Legalelectric, Inc.

February 26, 2010

RE: DEIS Comments
CapX 2020 – Phase I – St. Cloud to Monticello

Figure 1 - Map of Corridor Upgrade and RES Update Projects

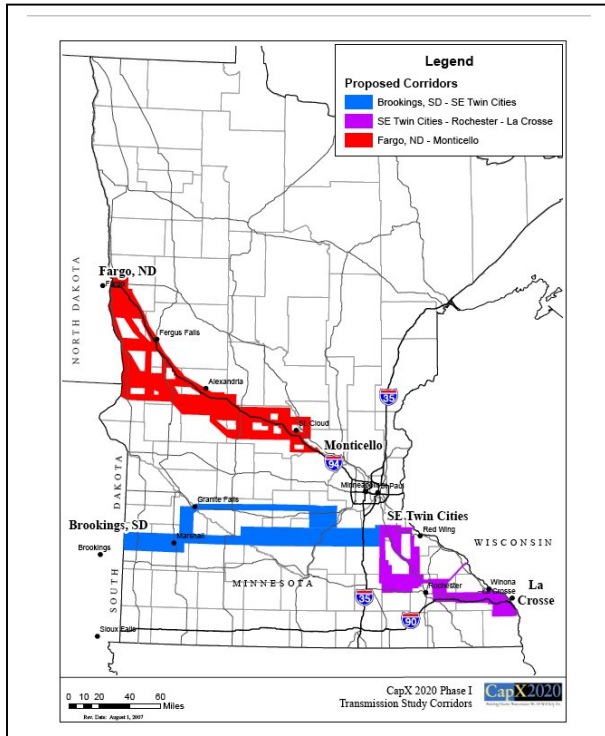
- The St. Cloud-Monticello EIS must address the “phased and connected” projects revealed in Xcel/GRE 4/3 Press Release (Attachment A) and the MTO Transmission Plan – the three projects in the Dakotas connecting with the Fargo terminus of this project have a direct impact on the impacts of this connected line. This group of projects is planned and not speculative.

CapX 2020 was developed as a whole, applied for as a whole and Certificate of Need granted as a whole.

CapX 2020 was studied and developed as a whole¹. This map, Attachment A, is from a CapX 2020 power point presentation to MAPP NM-SPG planning group on June 14, 2006. The blue solid lines are “Phase I,” applied for in the Certificate of Need proceeding before the MN PUC, order granting Certificate of Need May 22, 2009. The blue dotted lines are future lines, some of which were announced April 3, 2009. Attachment B is the April 3, 2009, press release regarding those lines.

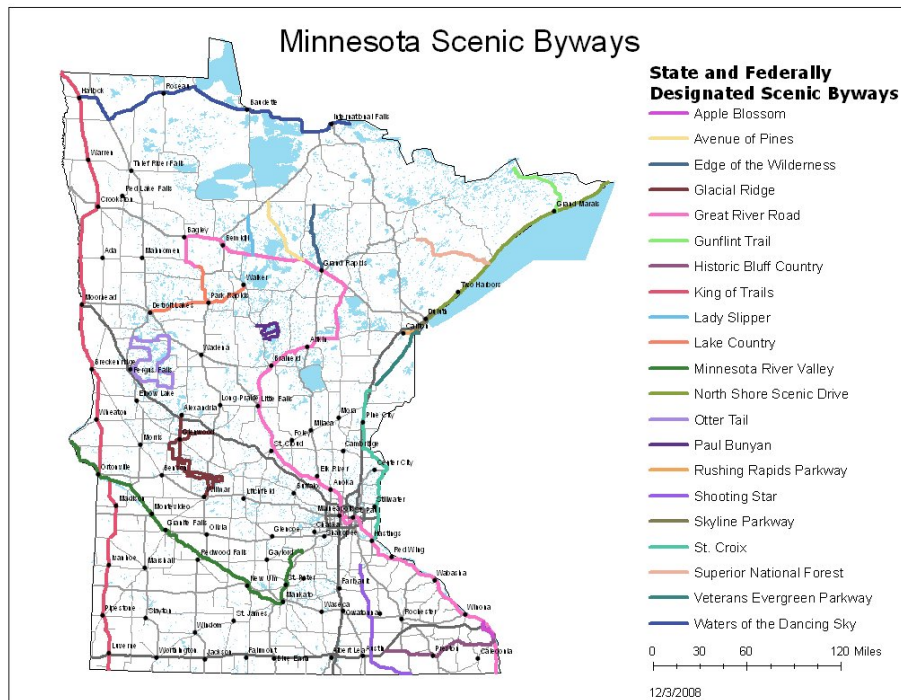
As with the Brookings CapX transmission line, the Monticello routes would cross the Minnesota Scenic Byways, in this case the Great River Road.

There is a likelihood that the Great River Road would lose its “Scenic Byway” designation if defaced by transmission lines.

The potential for economic impact must be specifically quantified. The state of Minnesota receives over \$10 million annually for its National Scenic Byways, and this number must be addressed not only in the section on Aesthetics, but in the Socioeconomic Impacts section. Coverage of these economic impacts
